FORM APPROVED
OMB NO. 1004-0135
Expires: July 31, 2010**SUNDRY NOTICES AND REPORTS ON WELLS**
*Do not use this form for proposals to drill or to re-enter an abandoned well. Use form 3160-3 (APD) for such proposals.*5. Lease Serial No.
NMNM94651

SUBMIT IN TRIPLICATE - Other instructions on reverse side.8. Well Name and No.
CEDAR CANYON 29 FEDERAL 3H9. API Well No.
30-015-42993-00-X110. Field and Pool, or Exploratory
PIERCE CROSSING11. County or Parish, and State
EDDY COUNTY, NM

OXY USA Inc. respectfully requests approval for the following changes to the approved APD:

1. Move Surface Location to a multi-well pad to accommodate skidding the rig.
2. Amend horizontal lateral
3. Amend casing/cementing/mud programs
4. Propose to run the wellhead through the rotary prior to cementing surface casing.
5. Pad Extension

Site Plan - 1

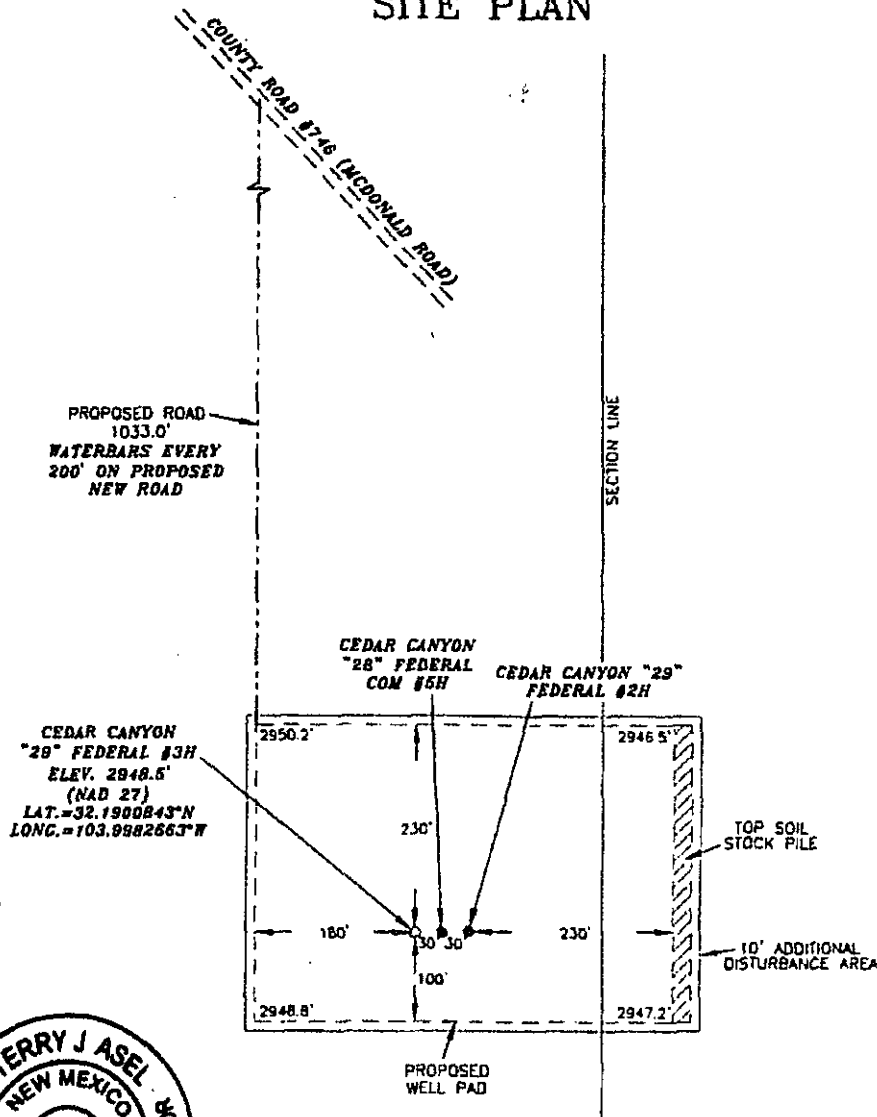
1. Amended C-102 and plats attached
New - SL-1990:ENL-210:FEL-SENE-29-BHL-2219-FNL-160-FWL-SWNW:Sec-29SEE ATTACHED FOR
CONDITIONS OF APPROVALED 12/2/15
Accepted for Record
RECORDEDNM OIL CONSERVATION
ARTESIA DISTRICT

Old - SL 1980 FNL 150 FEL SENE Sec 29 - BHL 1980 FNL 180 FWL SWNW Sec 29
